File No. D02-02-20-0035 and D07-12-20-0056

Subject: Zoning By-law Amendment and Site Plan Control (Complex) Applications- 243 and 245 Hinchey Avenue

Further to our recent discussions and meetings, we have revised the plans and report and the following summarizes what has been modified/changed. Responses in red text.

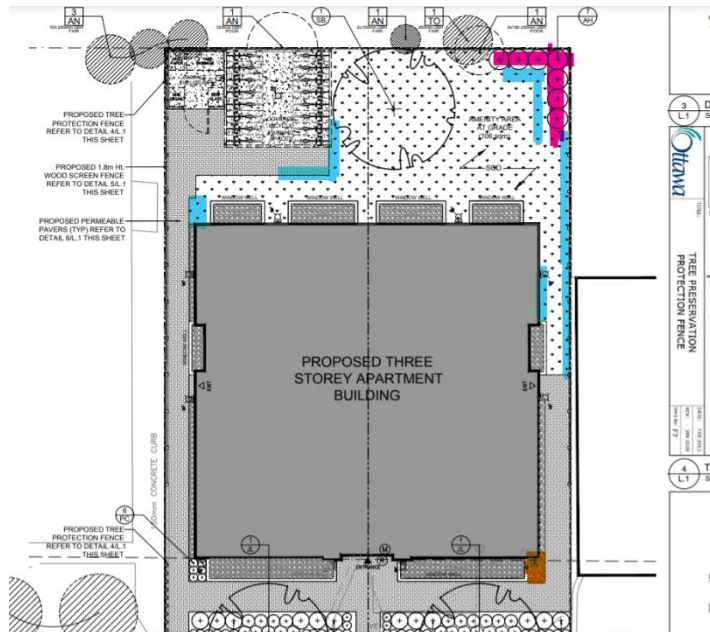
5. It is strongly recommended that more trees and/or perennials be added to the site, to ensure that the proposal complies with the new landscape minimum percentages. The more landscaping on site, the better. Areas where more landscaping could be included are shown in the image below for further consideration (magenta—consider adding an additional small tree, to increase canopy in the rear right-hand corner, and move the hostas further up towards the ISY; blue—areas where additional landscaping in the form of perennials would be highly beneficial; orange, in FY—consider adding landscaping here, to mirror the condition on the other side, which has landscaping (and helps visually soften the front). Any further additional landscaping in the FY would also be beneficial.

We have added soft landscaping in the front yard as per the comment above and we have also added a tree in the rear yard close the rear property line near the SE corner of the site.

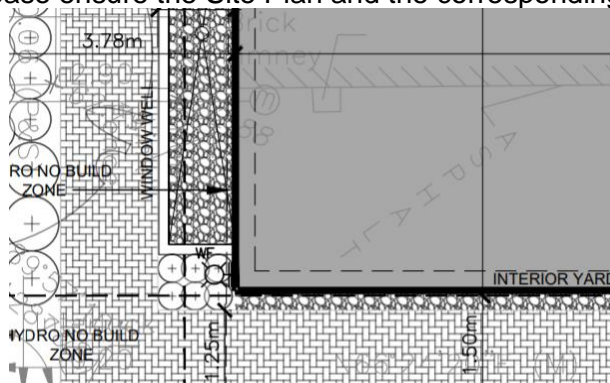
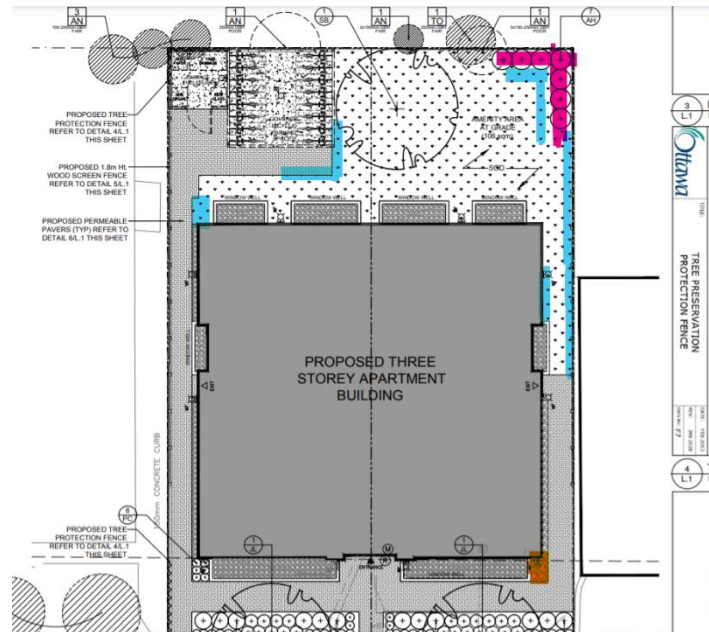
Please ensure the Site Plan and the corresponding Landscape Plan align.

Done

Done. Additional landscaping at the front and rear of the site.
